South Texas Project Electric Generating Station P.O. Box 289 Wadsworth, Texas 77483

February 10, 2006
NOC-AE-06001969
10CFR50.36
10CFR50.90

South Texas Project
Units 1 and 2
Docket Nos. STN 50-498, STN 50-499
Response to NRC Requests for Additional Information on
STPNOC Proposed Risk-Informed Technical Specifications

**Request For Additional Information Needed To Complete The
Technical Review of the South Texas Project (STP) Risk-Managed Technical Specifications
(RMTS) Initiative 4b Full Plant Pilot**

Comparison of Planned and Actual Risk (ICCDP) for Unit 2 During SDG 22 Outage

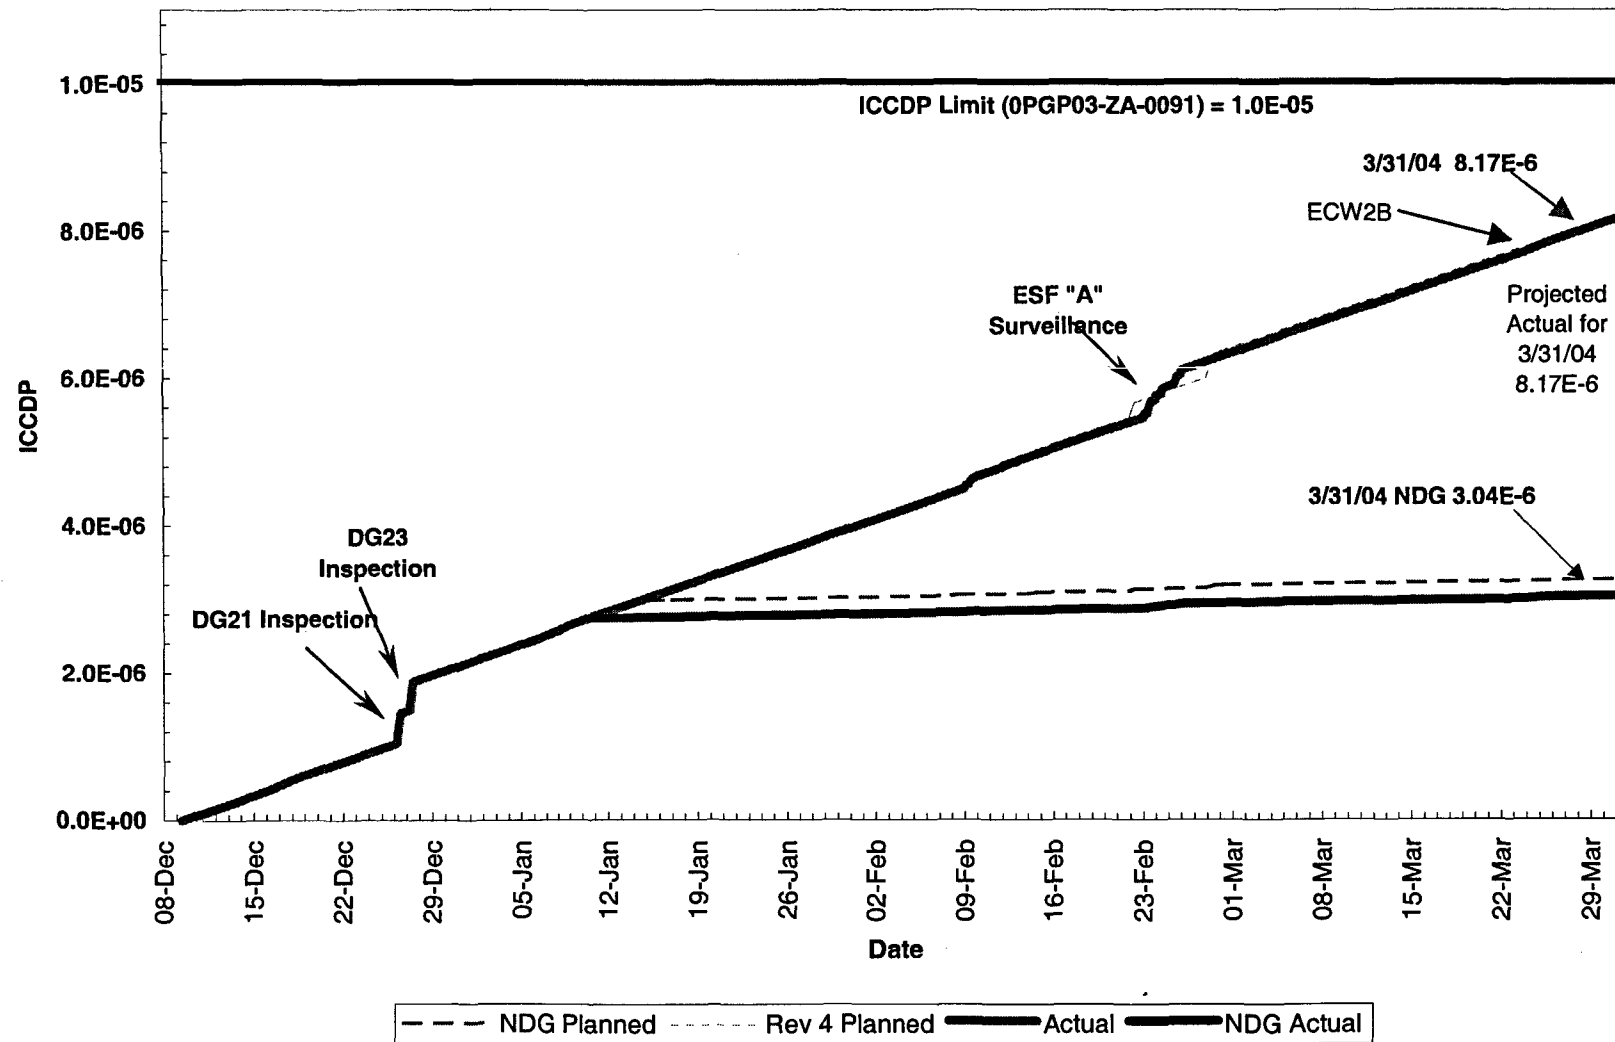
21. **The staff has been granting SDG AOT extensions up to 14 days provided the licensees have installed an extra A.C. power source or make available the alternate A.C. source installed to satisfy the requirements of station blackout rule. This extra power source can be substituted for an inoperable SDG during the extended AOT. Additionally, these requests are supported by a PRA analysis that demonstrates that overall risk is very low during the extended outage. In view of the above, provide justification for extending the AOT beyond 14 days without an extra power source.**

STPNOC performed extensive evaluations to justify the one-time extension of the allowed outage time for SDG-22 (Unit 2, Train B) to 113 days. Although STPNOC installed temporary diesel generators as a compensatory action, the actual configuration risk for the SDG-22 extended outage without crediting the temporary diesel generators was less than 1E-05 (see attached figure).

For the application of the proposed amendment, STPNOC would be able to plan SDG maintenance with a duration less than the non-risk-significant threshold of 1E-06. For the SDGs, this duration would be about 19 days for the Train A SDG, and the 30-day backstop for Train B and Train C SDGs.
